PLANNING AMENDMENTS

**TWICKENHAM STADIUM
 EAST STAND EXTENSION**

LEVEL 5A PLAN - SOUTH

Doc ref	Project number	Drawing number	Revision
100-KSS-DR	15735	154	P02

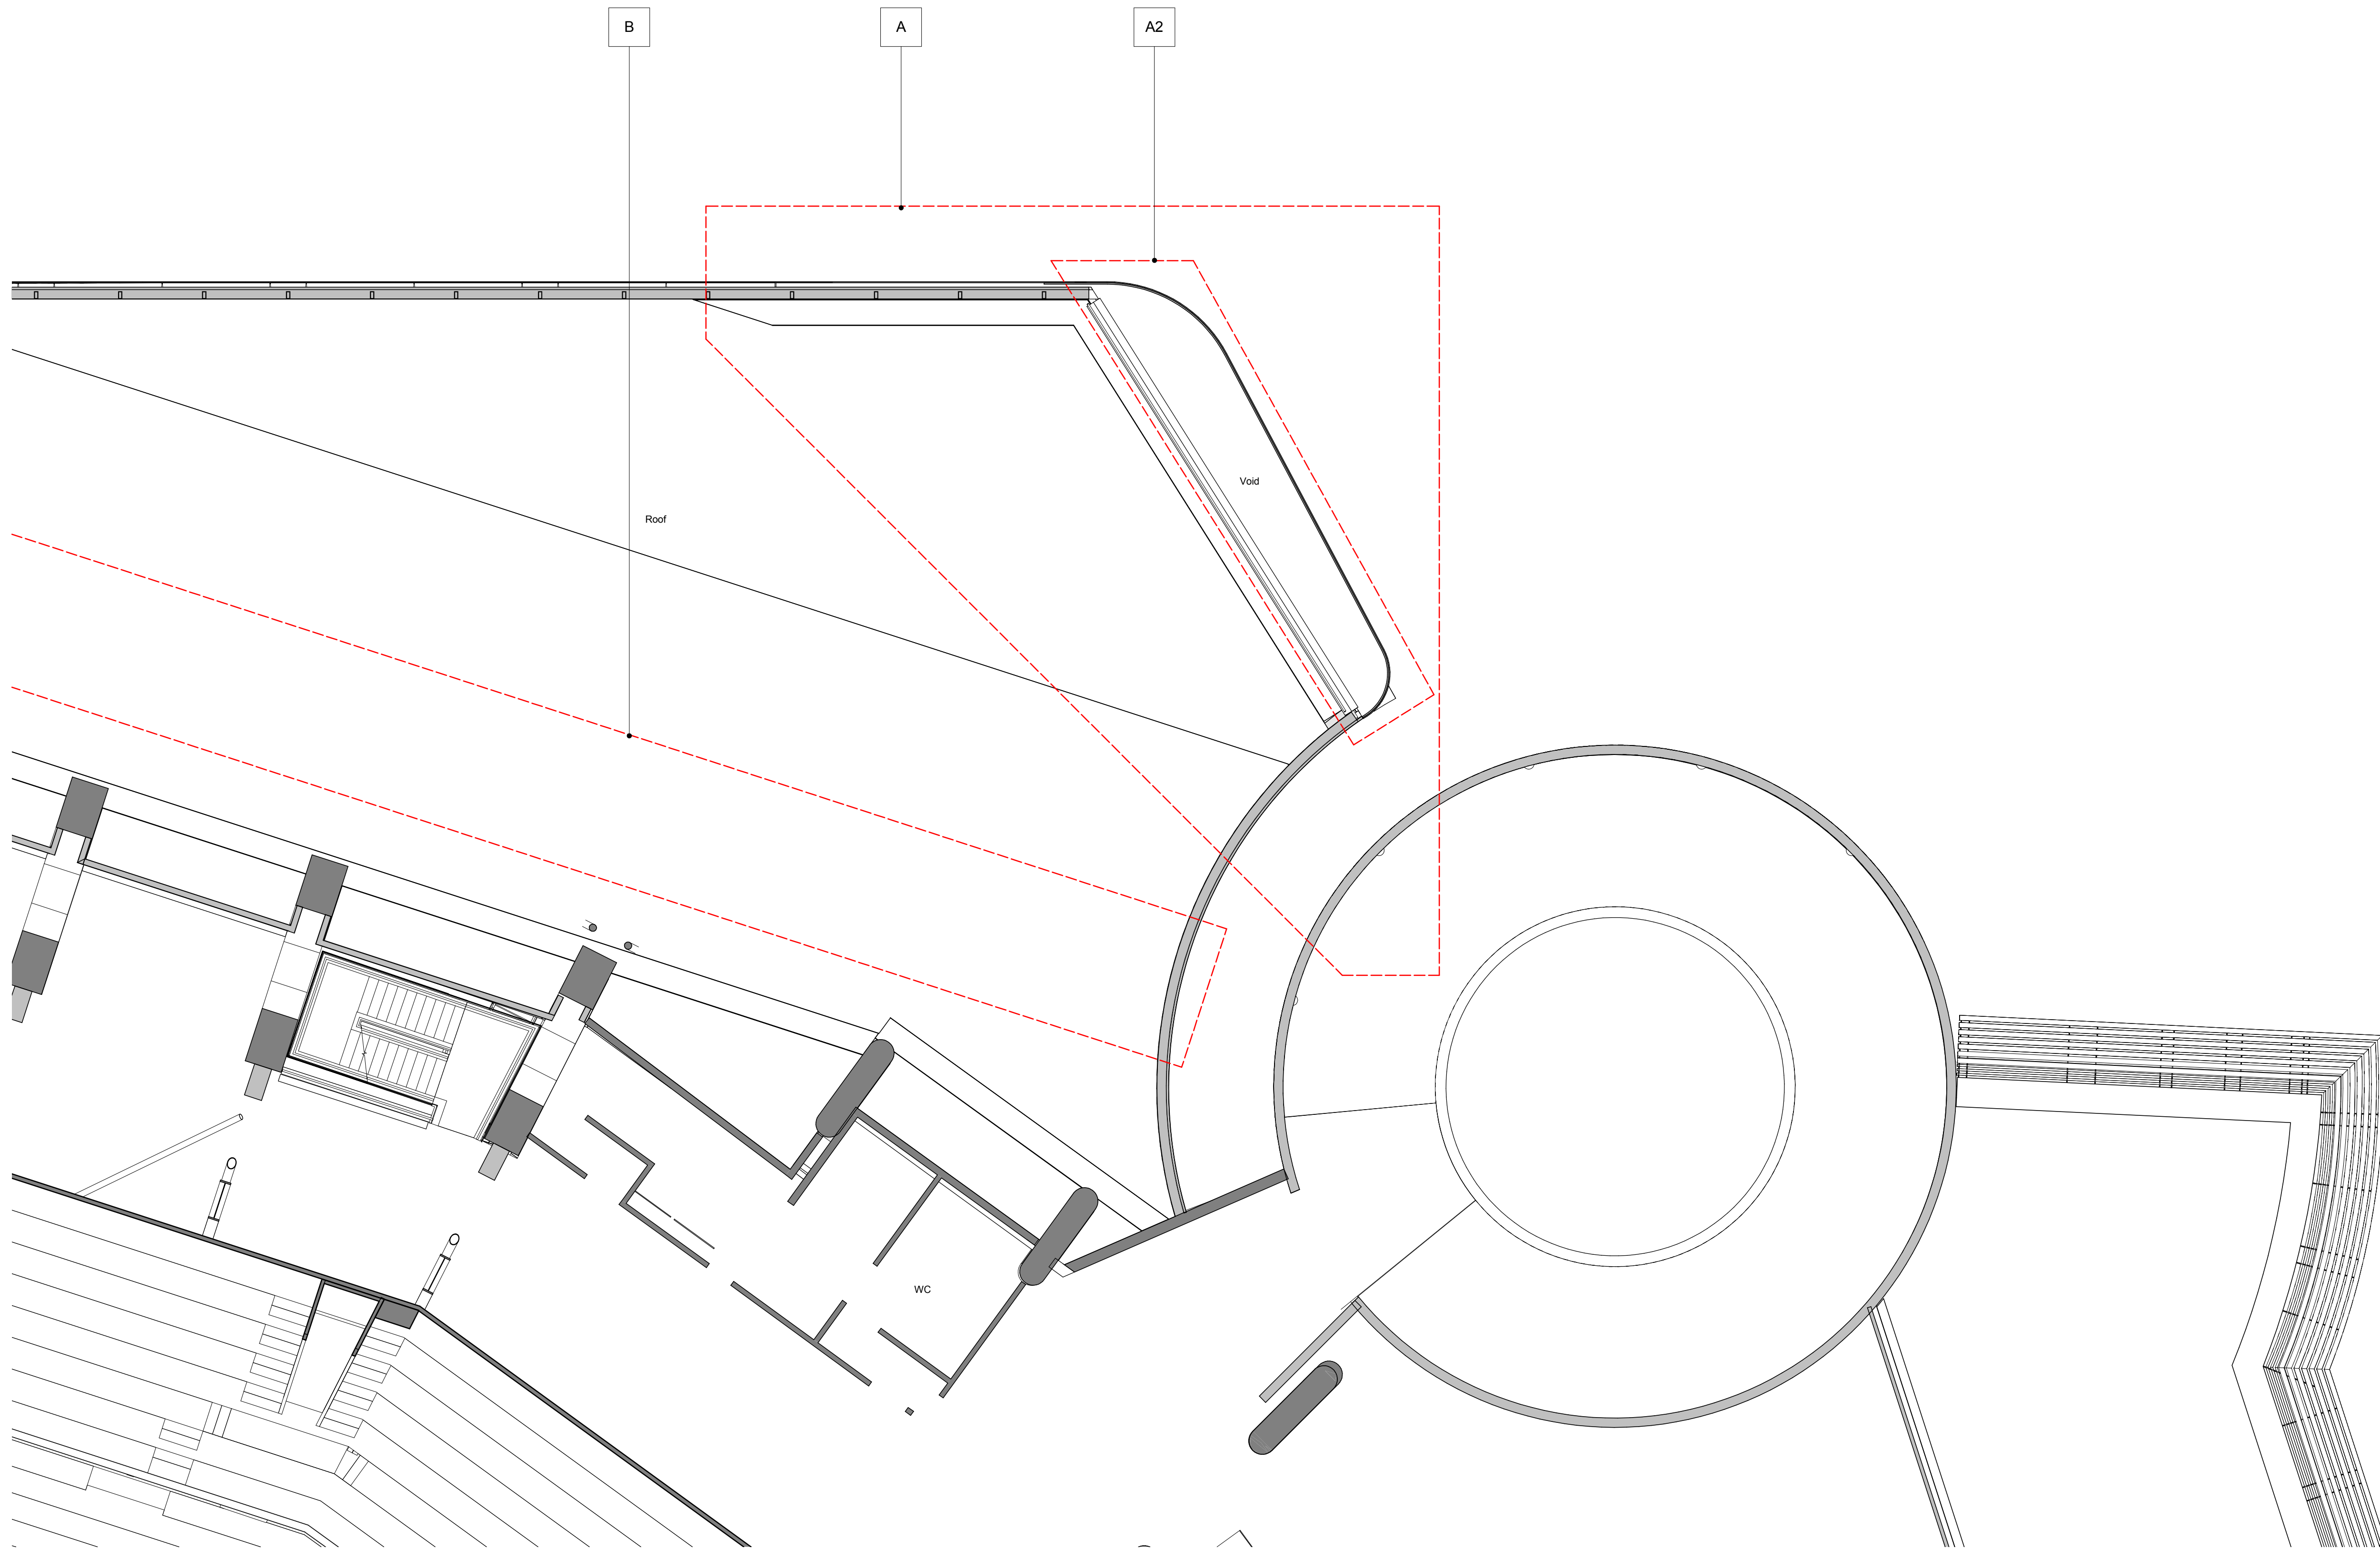
- A GENERAL AMENDMENTS TO THE SOUTH END.
- A1 INCREASED SHINGLES CLADDING AREA AND CURTAIN WALL REDUCED ACCORDINGLY.
- A2 REDUCED MASSING AND REVISED INTERFACE WITH THE SOUTH STAND.

- B PPC LOUVRES LOCATED TO THE BOWL SIDE HAVE BEEN OMITTED.
- C CURTAIN WALL SETTING OUT REVISED GENERALLY. SILICONE JOINTS TO TRANSOMS AND MULLION REPLACED WITH CAPPED SYSTEM. LEVEL 04 PPC LOUVRES SETTING OUT & HEIGHT REVISED. MONORAIL FOR ABSEILING REMOVED.

- D GENERAL AMENDMENTS TO THE CENTRAL ELEVATION CANOPY AT LEVEL 5A REVISED GENERALLY AND STANDING SEAM REPLACED WITH SINGLE PLY MEMBRANE. SUPPORT COLUMNS TO ROOF CANOPY REVISED. SQUARE FASCIA TO ROOF EDGE.

- D1 LEVEL 5A GLAZED SCREEN EXTENDED IN HEIGHT AND PPC LOUVRES INCLUDED AT LOW LEVEL.
- D2 INCREASED SHINGLES CLADDING AREA AND CURTAIN WALL AREA REDUCED ACCORDINGLY. FOUR VERTICAL FINIS REMOVED.

- D3 PORCELAIN PANELS WITH SLOTTED HOLES FOR VENTILATION REPLACED WITH PPC LOUVRES. EXPRESSED HORIZONTAL PATTERN TO PORCELAIN PANELS OMITTED.
- E GENERAL AMENDMENTS TO THE NORTH END

- E1 PORCELAIN CLADDING REPLACED WITH PPC ALUMINIUM CLADDING.
- E2 GREEN WALL TO THE NORTH END EXTENDED AND PPC LOUVRES REMOVED.
- E3 INCREASED SHINGLES CLADDING AREA AND CURTAIN WALL REDUCED ACCORDINGLY.

- F FENCELINE, GATE AND PERIMETER COLUMNS SETTING OUT REVISED.
- F1 CANOPY TO TURNSTILES REVISED.
- G PORCELAIN PATTERN CHANGED FROM HORIZONTAL TO VERTICAL.

- H PORCELAIN PANELS TO THE SOFFIT OF THE ARCH REPLACED WITH PPC ALUMINIUM PANELS. PORCELAIN PANELS SETTING OUT REVISED.
- K ROOF TO LEVEL 5A (NORTH END) EXTENDED.

- L GLAZED SPANDREL PANELS REPLACED WITH METAL SPANDREL PANEL. PORCELAIN PANELS REPLACED WITH PPC ALUMINIUM CLADDING.
- L1 PPC LOUVRES INCLUDED FOR MECHANICAL VENTILATION.
